CS Memorandum No. 1685

Subject: Configuration Management Board Meeting No. 166

CMB Meeting Minutes #166

SUBJECT: Configuration Management Board Meeting # 166 – Rev. No. 0

THIRD STREET LIGHT RAIL PROGRAM
 PHASE 2 - CENTRAL SUBWAY TUNNELS
 AUXILIARY WATER SUPPLY SYSTEM WORK
 LOCATION 6
 NEW WORK - PLAN

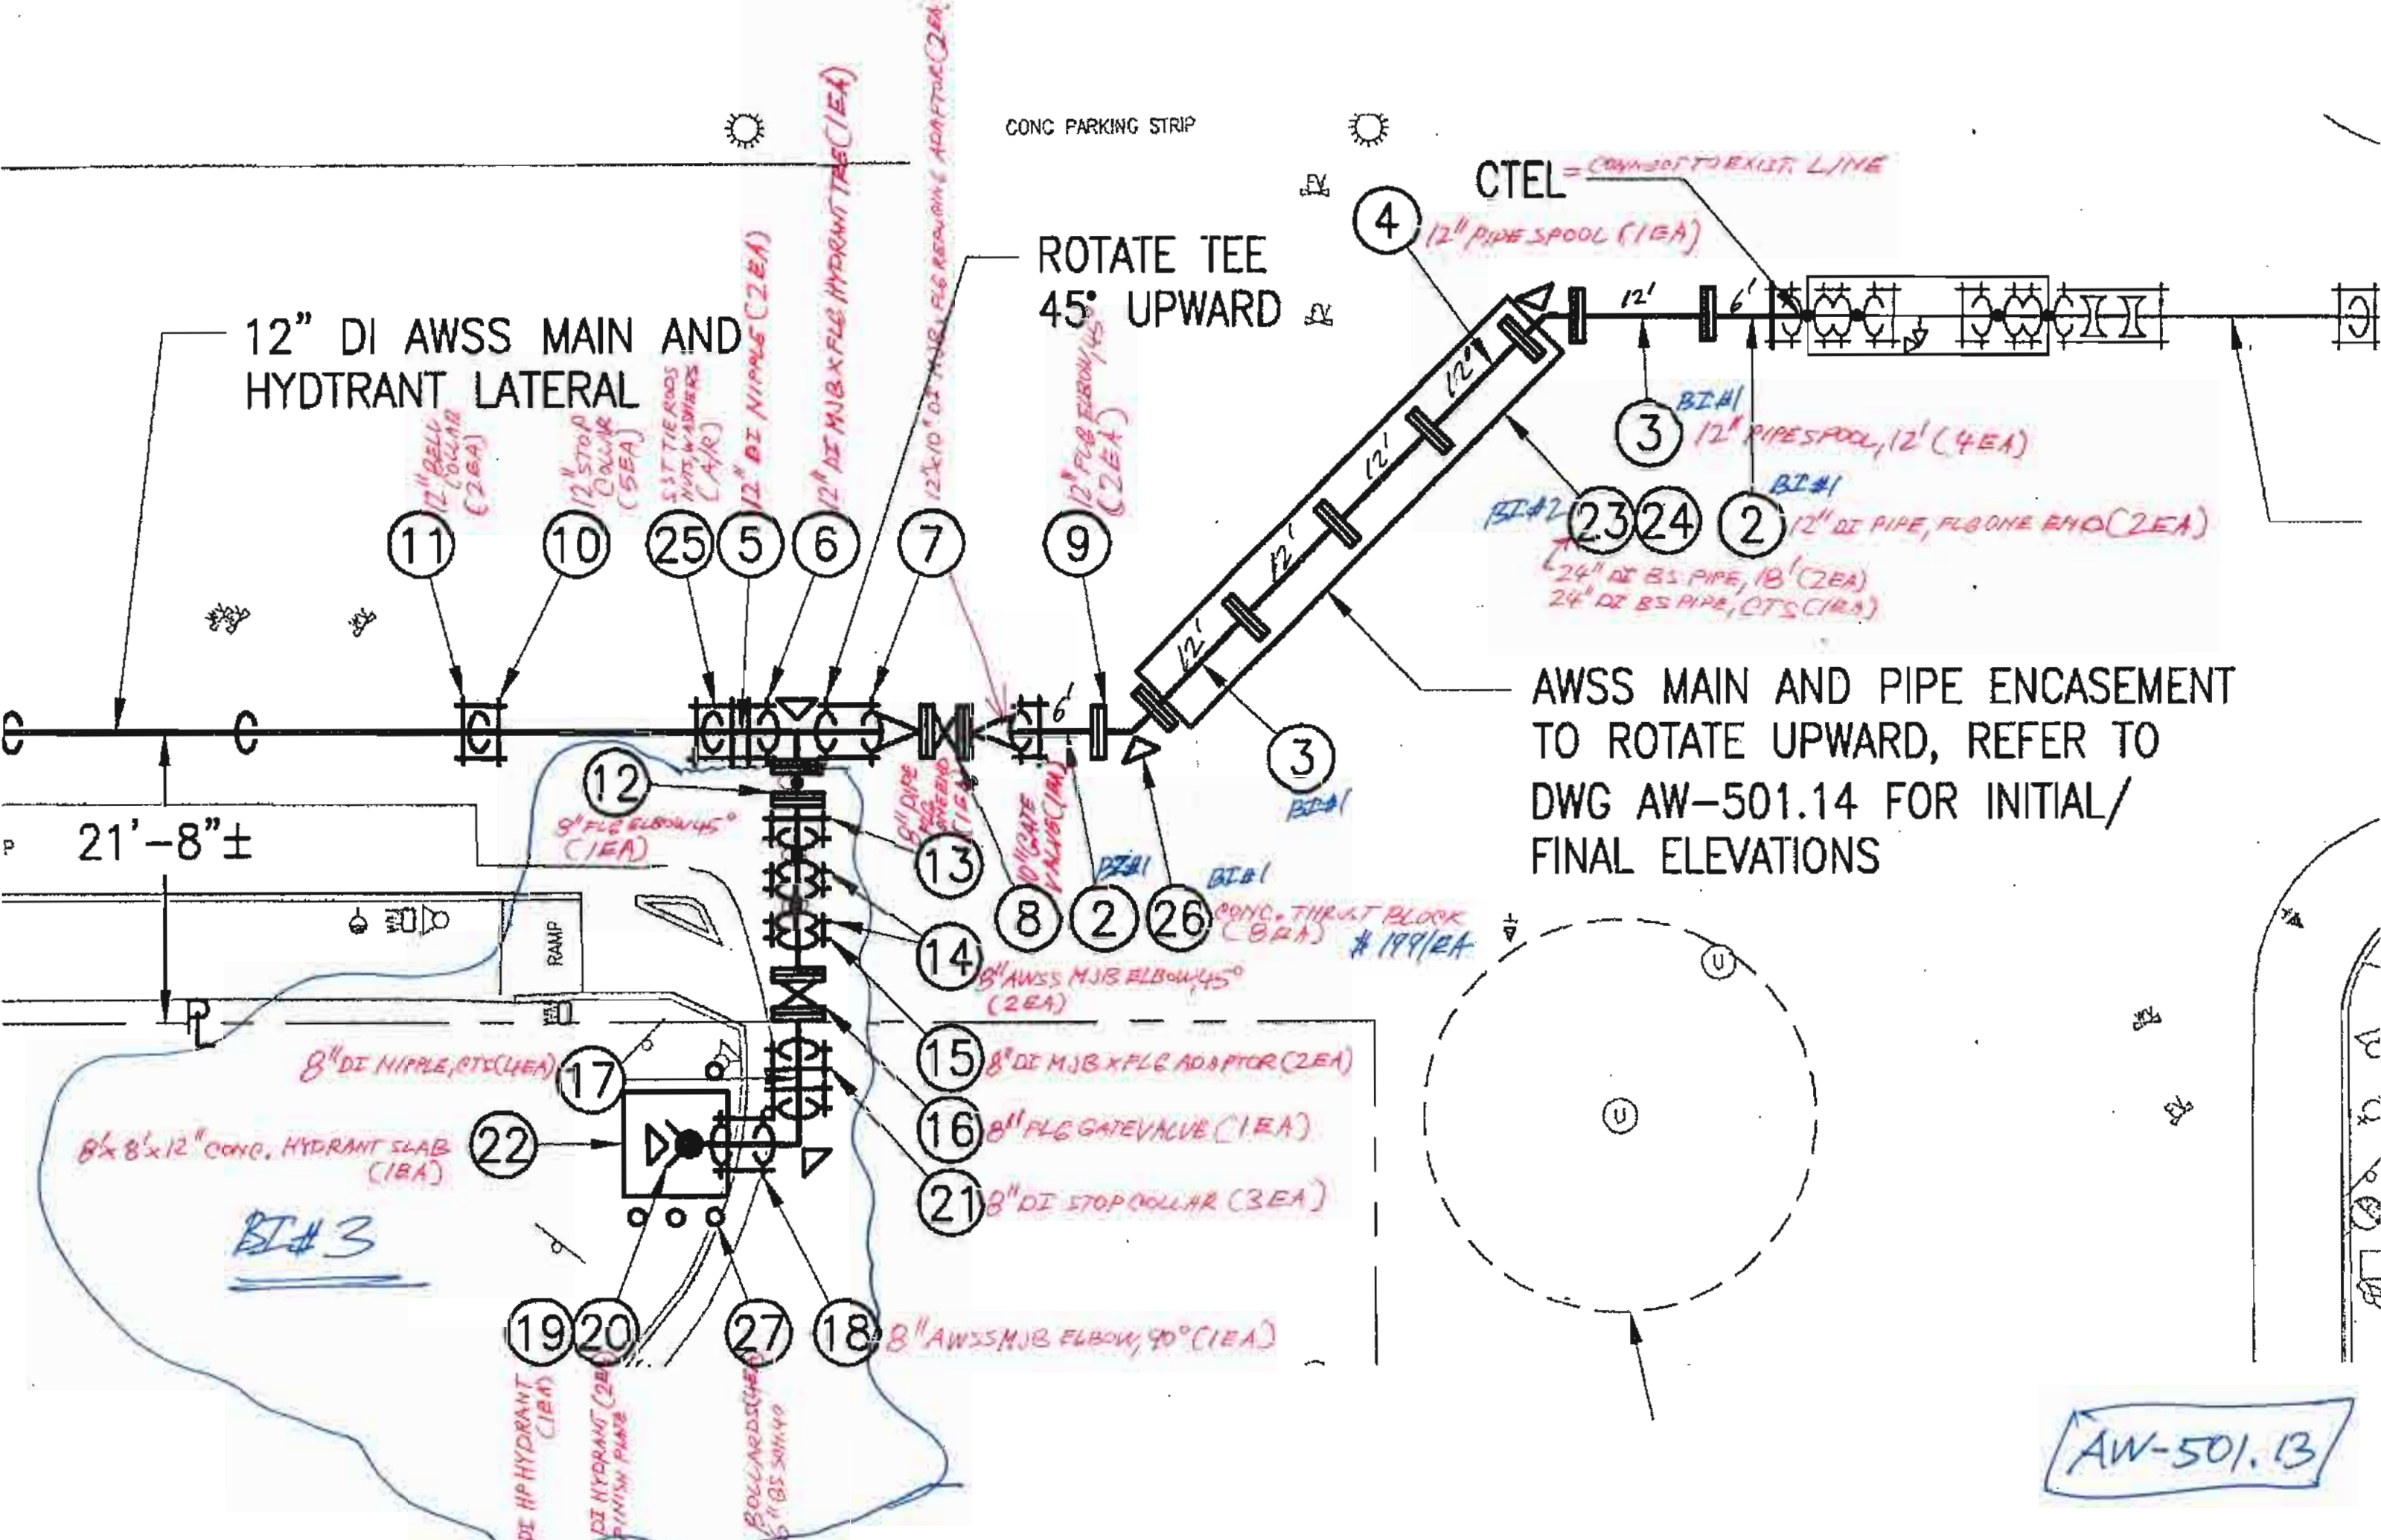
DELETE FROM WORKSCOPE 12" DIAGONAL FLANGED PIPE AND ENCASMENT. SEE SEPARATE SHEET FOR CAPPING AND EXTENDING (E) LINE

F/I HYDRANT LATERAL W/AIR VALVE AND VERTICAL OFFSET. SFDPW WILL PROVIDE DESIGN SKETCH FOR PIPING LAYOUT AND EXACT LOCATION FOR TB PRIOR TO 2015 12" DI AWSS PIPE INSTALLATION.

DELETE FROM WORK SCOPE HYDRANT LATERAL DOWNSTREAM OF TEE, INCLUDING CONCRETE PAD AND BOLLARDS #BI#3

**UT-100
CONTRACT
DRAWING**

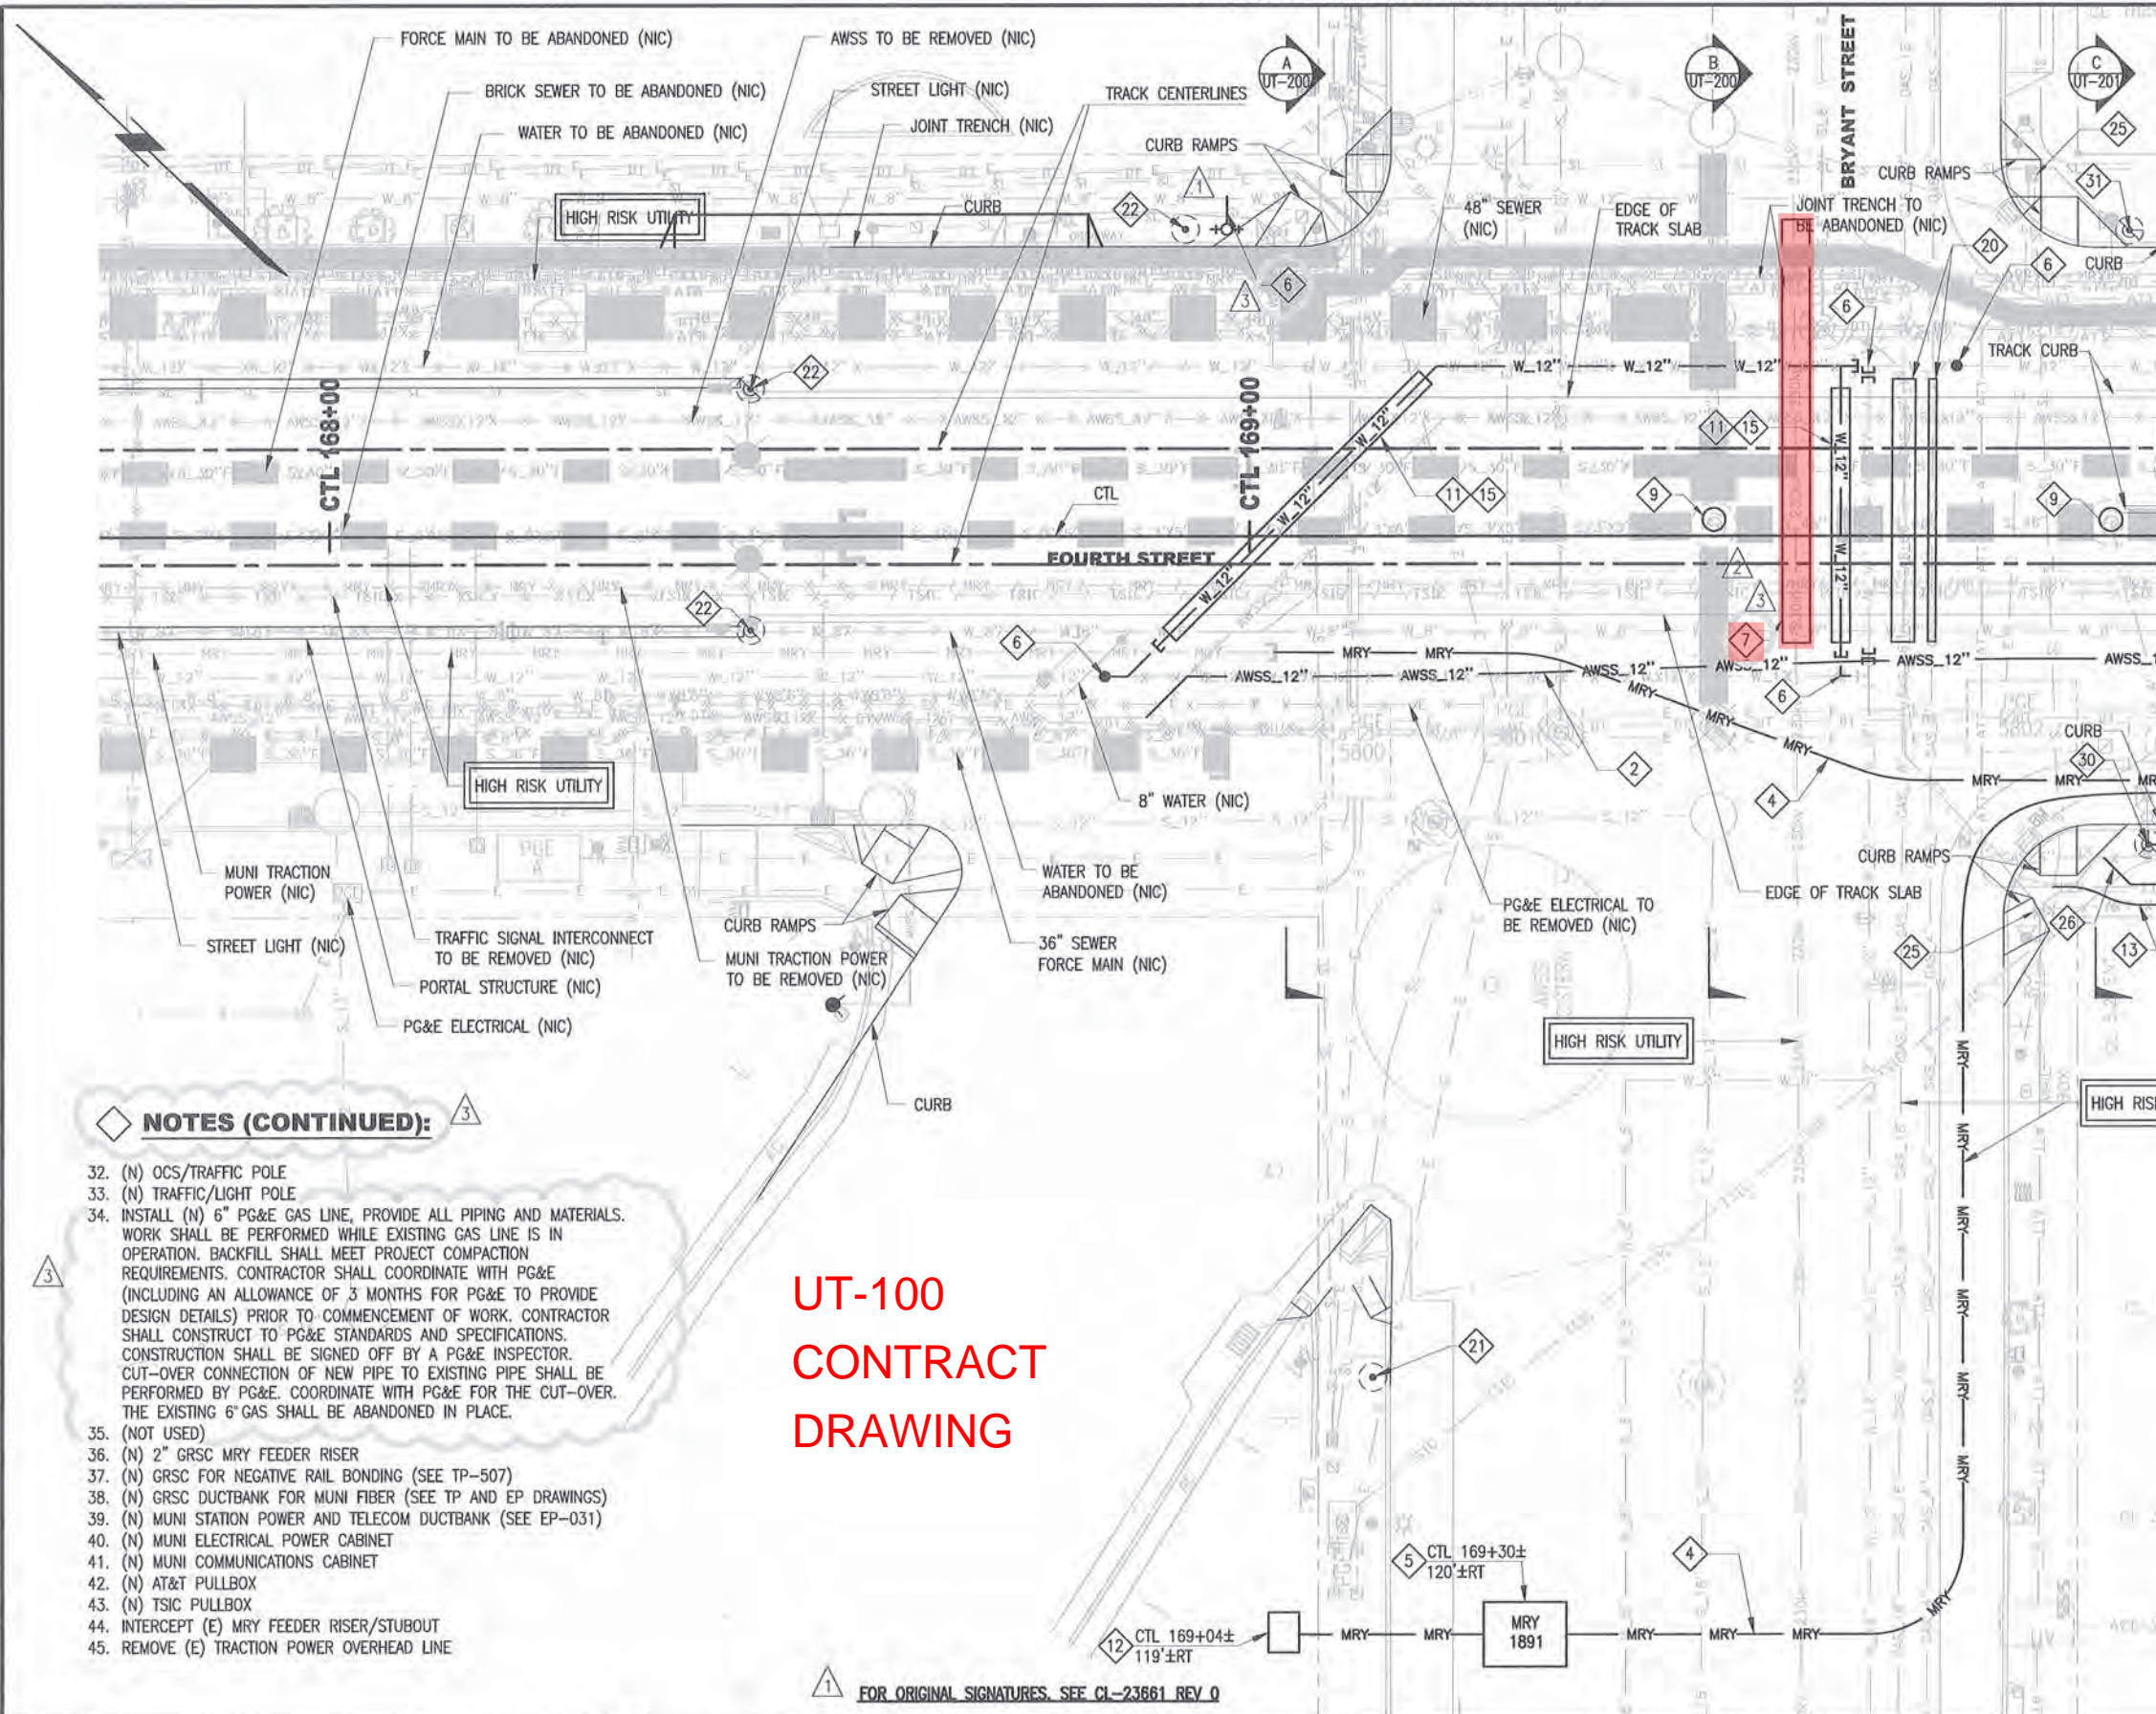
<p>Description of PCC:</p> <ol style="list-style-type: none"> 1. Furnish and install 126 linear feet of 20" epoxy coated steel casing at 4th/Bryant, including shoring, excavation, temporary and permanent restoration of roadway and testing. 2. This is a Form B reimbursable work. PG&E has provided SFMTA authorization of NTE \$10,000 to prepare a PCC. See attached PG&E Letter dated January 17, 2014.
<p>Reason/Need for PCC:</p> <ol style="list-style-type: none"> 1. Contract Plan UT-100 shows a 46 linear feet of 20" casing. Per Sheet Note No. 7, casing is to be furnished and installed by PG&E. 2. PG&E wants to extend the casing length to 126 feet to bring the ends of the casing outside of the intersection for easy access. 3. In addition, PG&E wants Tutor Perini to perform the work provided that cost is reasonable.
<p>Location/Station: Intersection of 4th Street and Bryant Street.</p>
<p>Configuration Control Analysis: The additional work contained in this PCC does not alter the original intent of the contract, which is to provide a 20" casing underneath the track bed should the existing 230 Kv ductbank be required to be relocated in the future.</p>

- PG&E SHALL SUPPLY AND INSTALL NEW CASING TO PROTECT THE EXISTING (E) PG&E 230KV ELECTRICAL TRANSMISSION. CONTRACTOR SHALL ALLOW 12 MONTHS LEAD TIME FOR PG&E PROCUREMENT OF THE CASING. CONTRACTOR SHALL COORDINATE WITH PG&E AND PROVIDE TRAFFIC MANAGEMENT, EXCAVATION, AND SHORING TO ACCOMMODATE PG&E WORK.

<p>Recommended Action:</p> <ol style="list-style-type: none"> 1. Recommend to approve for merit and issue PCC to the contractor to obtain a cost proposal. PG&E will review the cost proposal and make a determination whether to include installation of casing as part of Contract 1300 or self-perform the work.
<p>Estimate: Rough Order Magnitude estimate is \$137,337 based on prior Central Subway estimate of a 24" waterline. A detail estimate is forthcoming.</p>
<p>Spec. Ref.: Technical Specifications 33 34 05</p>
<p>Drawing Nos.: UT-100 Utility Composite Plans (Conform and Sketch)</p>
<p>Attachments: Technical Specifications 33 34 05, UT-100 Utility Composite Plans (Conform and Sketch), PG&E Letter</p>
